Technical Service Bulletin

GROUP	NUMBER
BODY	25-BD-013G
DATE	MODEL(S)
DECEMBER 2025	G70 (IK)

SUBJECT: WIDE SUNROOF CREAK/RATTLE NOISE ON UNEVEN ROAD CONDITIONS – REPAIR GUIDE

This TSB supersedes 22-BD-007G to expand the Applicable Vehicles' production date range through 2023MY and to add a step (28) in the service procedure on page 15 for lubricant application on the front locator.

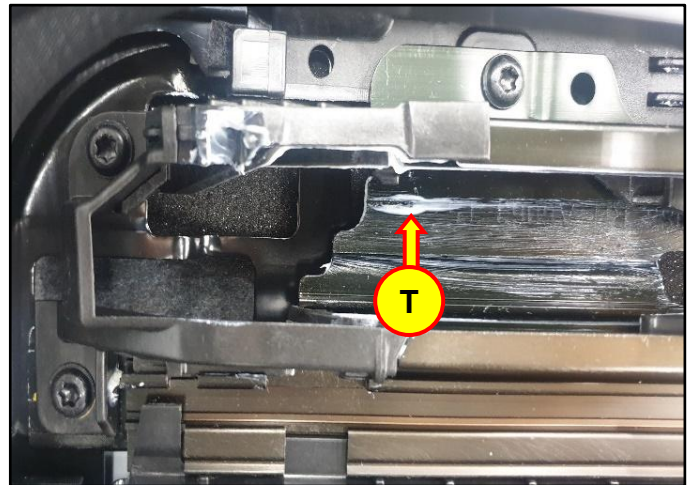
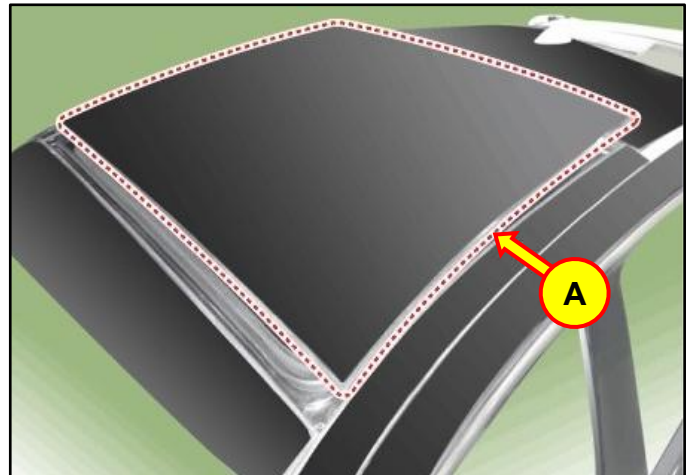
28. Apply silicone lubricant to the front locators in the specified areas (T).

Apply more silicone lubricant to the area (T) on the top of the front locator.
